United States Department of the Interior
BUREAU OF SAFETY AND ENVIRONMENTAL ENFORCEMENT
Gulf of Mexico OCS Region
1201 Elmwood Park Boulevard
New Orleans, LA 70123-2394

Application Type: Right-of-Way Route Modification

Work Description: Request to modify pipeline by partial relinquishment, partial abandonment and installation new pipe to connect to segment no. 3034. The to-be abandoned portion of the pipeline is given segment number 18881. This modification is being done to go around the to-be removed South Marsh Island Block 58 A Platform.

Re: Application to Modify Existing 8-inch Oil Right-of-Way Pipeline by Partial Relinquishment, Partial Abandonment and Installation of New Pipe, Segment 15585 ROW OCS-G 01681B Originating at a Subsea Tie-in Located in Vermilion Block 255 and Terminating at A Platform, South Marsh Island Block 58, Offshore Louisiana

CRIMSON GULF, LLC
SM-58 A PIPELINE ABANDONMENT PLAN
DRAWING NO.3043.00-114 REVISION NO. 0

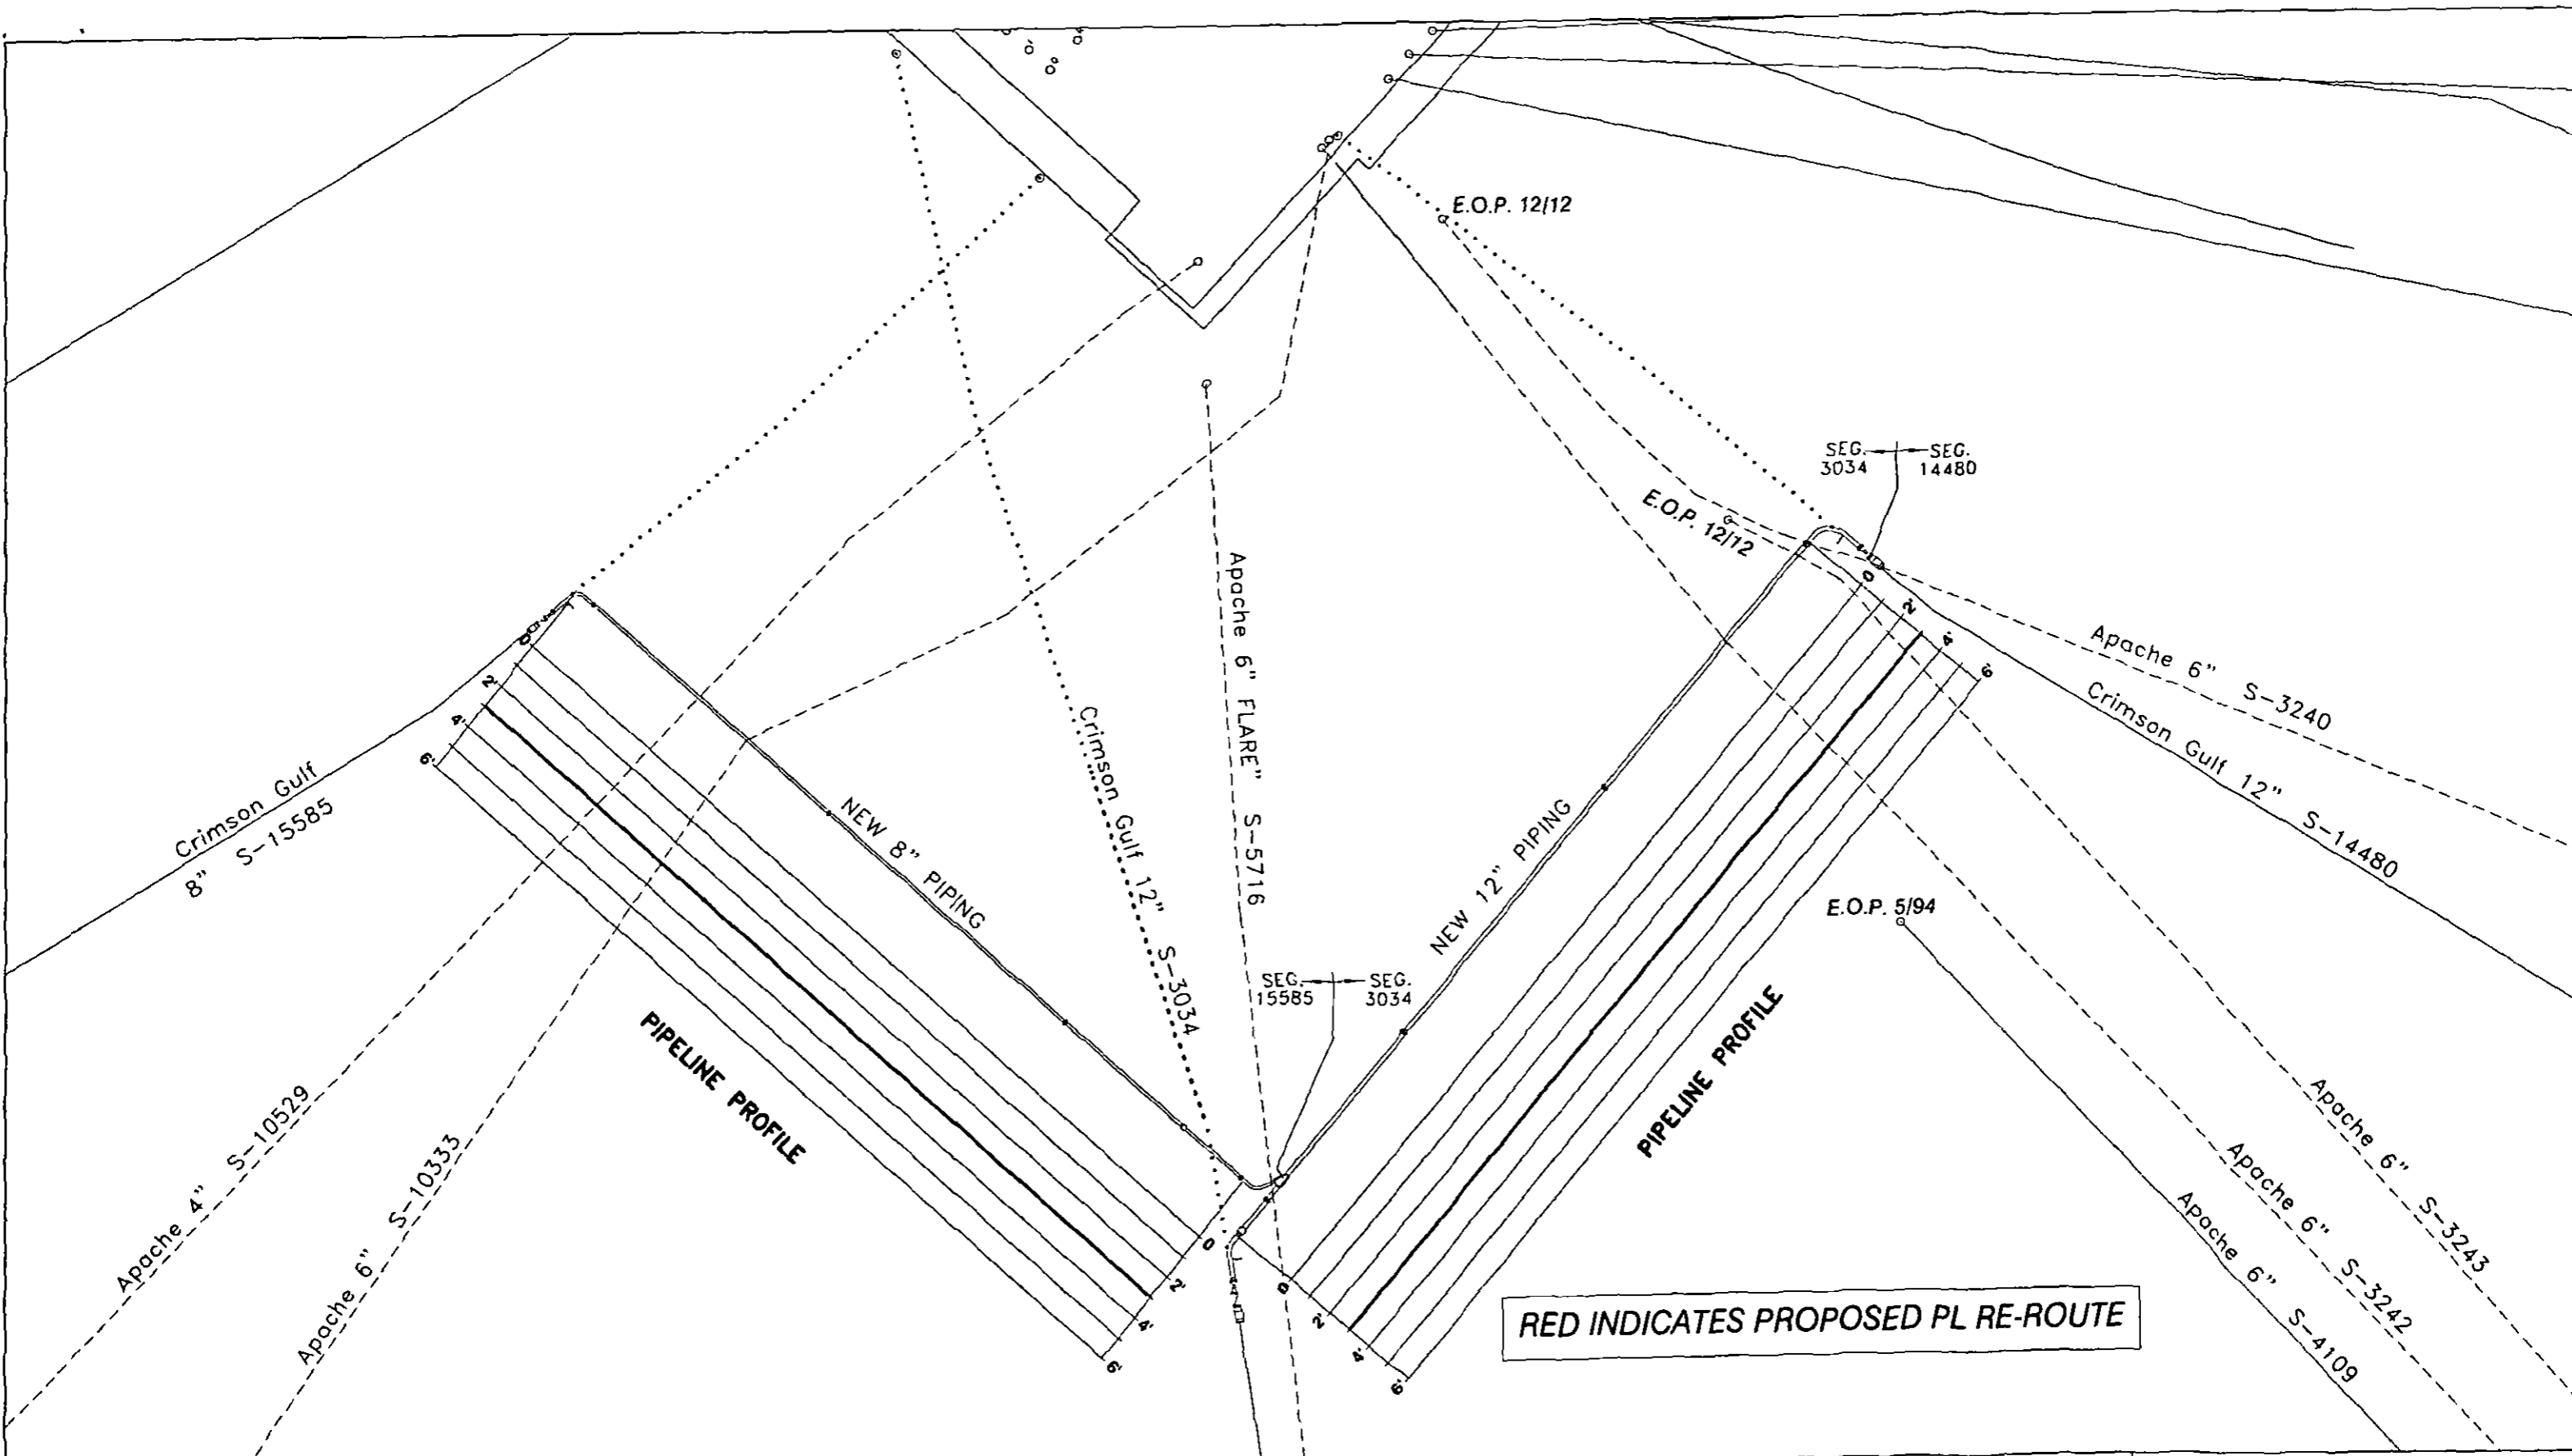
In regards to the SM-58 Piping that will be decommissioned (near the platform), see answers to your questions below.

From: Patton, Frank [mailto:frank.patton@bsee.gov]
Sent: Monday, February 25, 2013 9:02 AM
To: Gaby Medrano
Subject: Crimson Gulf SM 58 Route modifications
